CITY OF AUSTIN
Board of Adjustment
Decision Sheet
D-2

CASE NUMBER: C15-2021-0056

ADDRESS: 3006 GLENVIEW AVE

VARIANCE REQUESTED: The applicant is requesting a variance(s) from the Land Development Code, Section 25-2-515 (*Rear Yard of a Through Lot*) from setback requirements to decrease the minimum rear yard setback from 25 feet (required) to 5 feet (requested) in order to erect a detached garage/office in an "SF-3-NP", Single-Family Residence-Neighborhood Plan zoning district. (Windsor Road Neighborhood Plan)

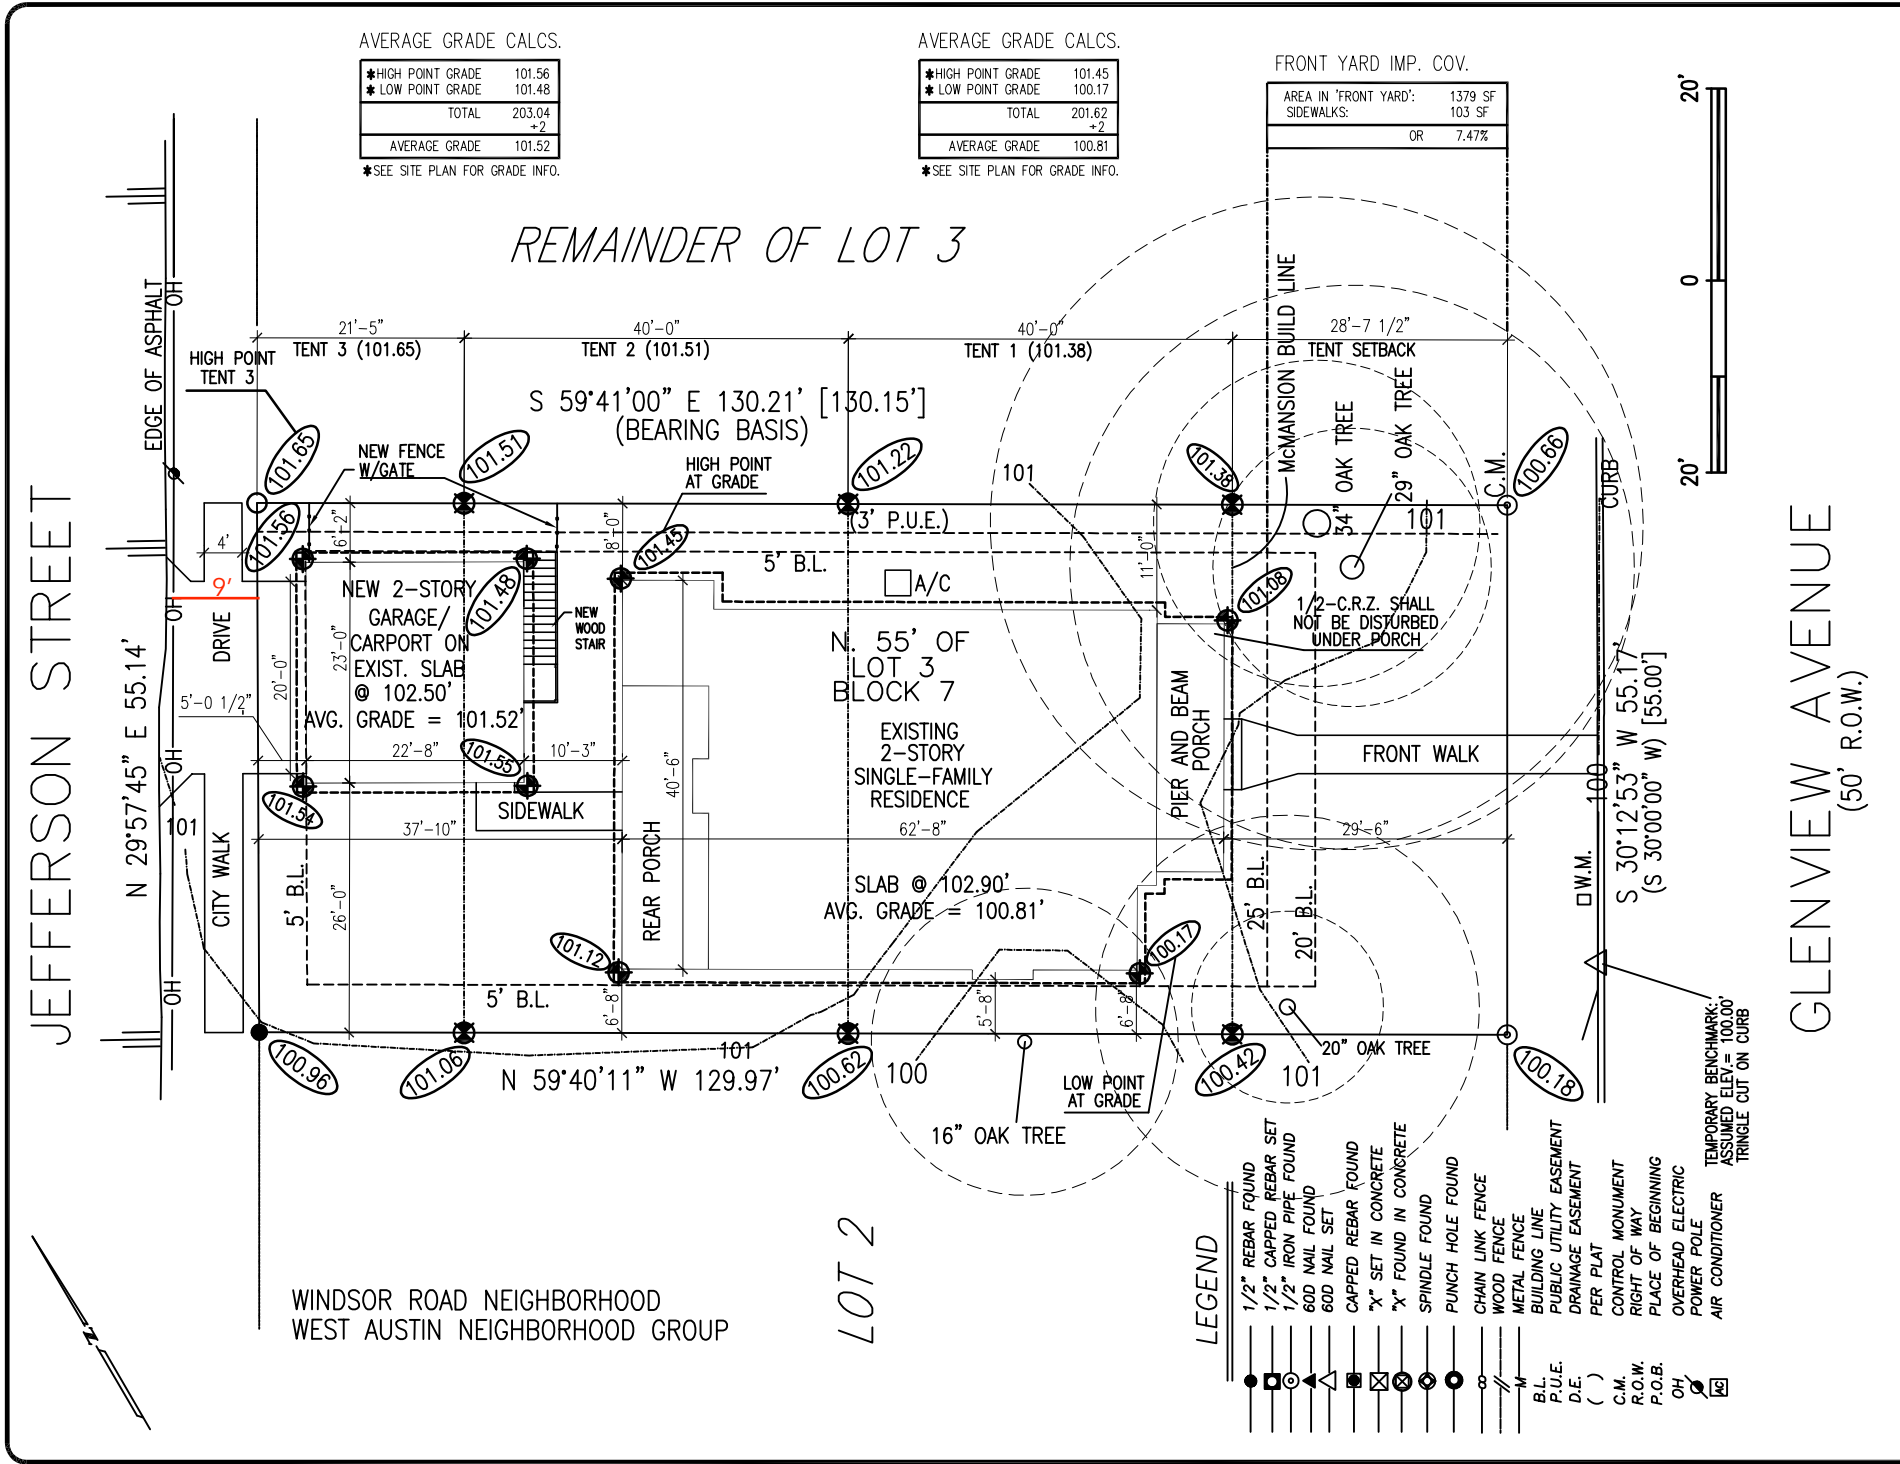
BOARD'S DECISION: BOA JULY 12, 2021 POSTPONED TO AUG 9, 2021 AE DENIAL FINDING:

Distance from the Center OH Line to the build line is 9'. Distance from BL to the structure is 5'0.5". Utility Pole has a cross beam 8' wide making the closest line approximately 5' from the BL. Therefore, distance from structure to the closest OH line is approximately 9.5'.

Austin Energy Design Criteria 1.10.0 - Clearance & Safety Requirements:

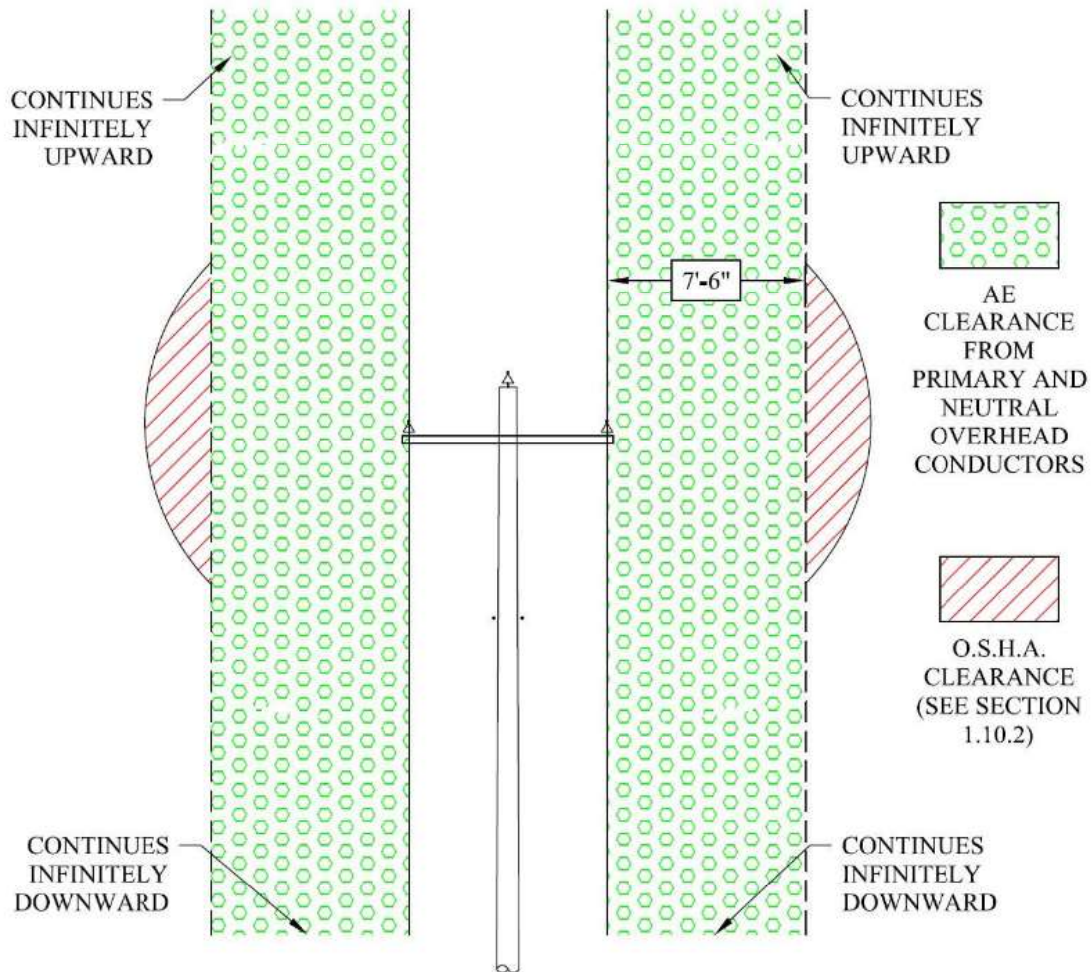
Austin Energy (AE) has reviewed your application for the above referenced property, requesting that the Board of Adjustment consider a variance(s) from Land Development Code Section 25-2-515 (Rear Yard Through Lot) in order to reduce the required rear setback from 25' to 5'. Austin Energy **opposes** approving this request until further detail regarding clearances can be provided.

While the request is similar to others approved in the area, for complete assurance, Austin Energy requests that the owner/applicant provide elevations of the proposed new structure, showing the building is able to meet the minimum horizontal clearance of 7 feet 5 inches from the outmost conductor, as required by Austin Energy's Design Criteria Section 1.10.0 (clearance & safety requirements). Below is a link to Austin Energy's Design Criteria, as well as a diagram depicting the horizontal and OSHA clearances required.
